**Request for Additional Information 564, Supplement 2**

**Application Title: U. S. EPR Standard Design Certification - Docket Number 52-020**

**Review Section: 08.02 - Offsite Power System**

**Question 08.02-8:**

### Overview U.S. EPR Offsite Power Supply Design for the EATs

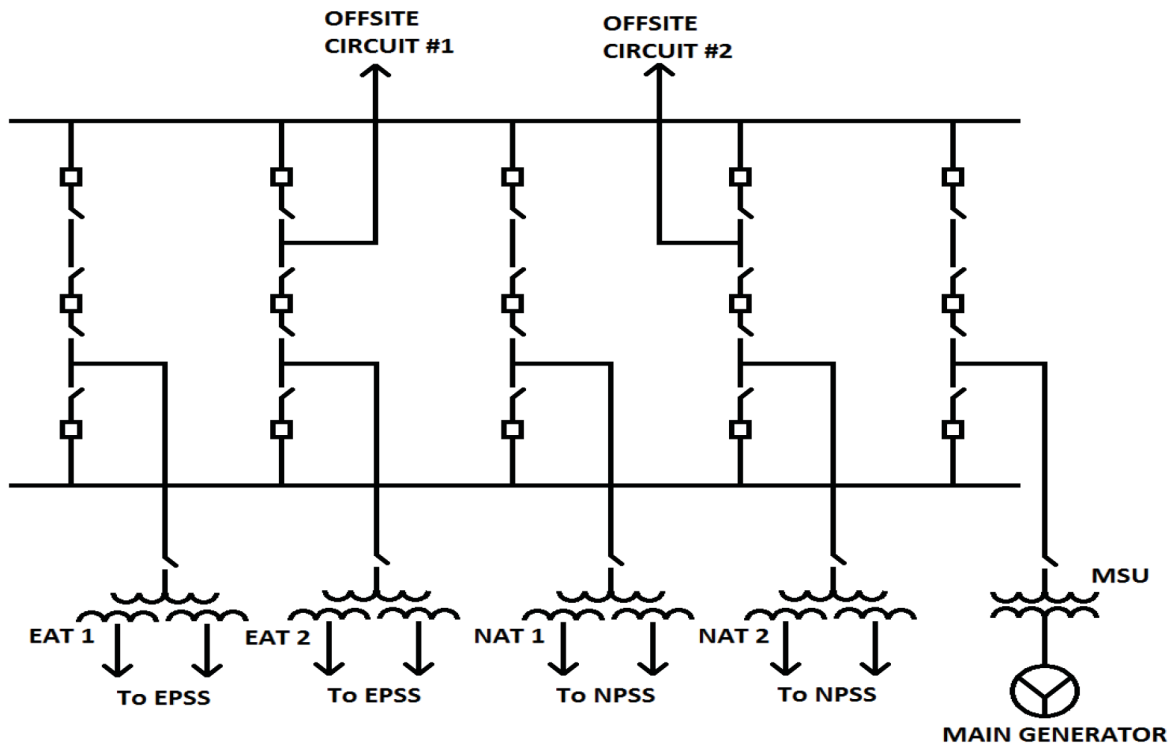
- Describe the protection scheme design for important to safety buses (31-34BDA) to detect and automatically respond to a single-phase open circuit condition or high impedance ground fault condition on credited offsite power circuits.
- If the important to safety buses are not powered by offsite power sources during at power condition, explain how the surveillance tests (e.g., SR 3.8.1.1) are performed to verify that a single-phase open circuit condition or high impedance ground fault condition on an off-site power circuit is detected.
- Describe the plant operating procedures including off-normal operating procedures, specifically calling for verification of the voltages on all three phases of the ESF buses.

The four Class 1E Emergency Power Supply System (EPSS) Buses 31-34BDA of the U.S. EPR design are powered from two, 25 MVA, 3-winding Emergency Auxiliary Transformers (EAT), 30BDT01 and 30BDT02. The three windings of each EAT are connected Wye; the primary, high-voltage side neutral is solidly grounded, and the two secondary, low-voltage side neutrals are each high-impedance grounded. Although each EAT has the capacity and capability to power all four EPSS buses (31-34BDA) under all design basis conditions, the normal operating configuration is for each EAT secondary winding to power a single EPSS bus.

The EATs are powered by dedicated off-site feeds that are not used for powering normal operation plant loads such as RCPs, Main Feedwater Pumps, etc. The Normal Auxiliary Transformers (NATs) supply the normal operations plant loads and have their own dedicated off-site power feeds. The U.S. EPR electrical system configuration also assures that should a loss of phase occur on one of the off-site feeds, the emergency buses and associated safety equipment powered by the second off-site feed are unaffected.

The U.S. EPR electrical system off-site power supply design provides a stable, dedicated and voltage regulated power source for the Emergency Buses. This configuration presents a somewhat unique relaying design challenge when trying to monitor for loss of a single off-site power supply phase due to the light loading of the EATs during normal at-power operation. This normal

operating configuration maintains the EATs very lightly loaded, roughly estimated at 5 to 8 MVA each.
